Service Bulletin

Bulletin No: JC-14-03

Product Type: Walk-Behind Mid-Size

Issue: Belt could ride off the top side of the tension pulley

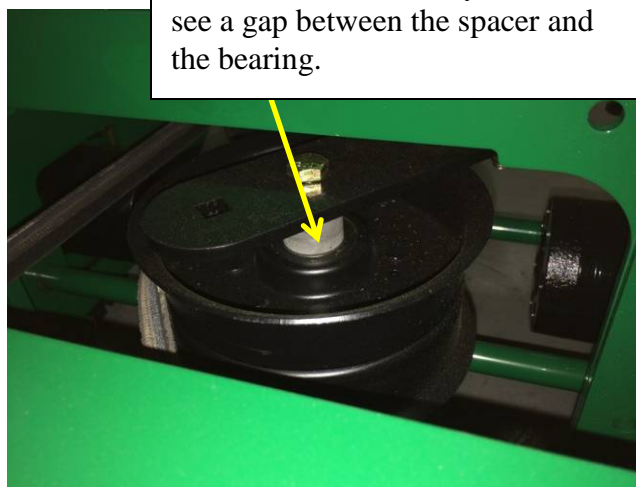
Cause: Spacer is not pressed all the way into the bearing of the PTO tension idler (2721541).

Action Required: Visually inspect the unit. The inspection for this can be done without any disassembly. From the front of the mower, this pulley will be located where the deck meets the power unit, as shown below.

This is correct. Notice you do not see a gap between the spacer and the bearing.

For clarity the spacer was removed to show the shoulder which needs to be seated against the bearing race.

This is wrong. Shoulder on spacer is not seated tight against bearing race.

- 1) Apply 30 ft. lbs. of torque to the bolt and nut holding the idler on; this will typically seat the bushing properly.
- 2) If you encounter a very tight fitting spacer that will not go into the bearing with 30 ft. lbs. of torque, you will need to replace the idler pulley.
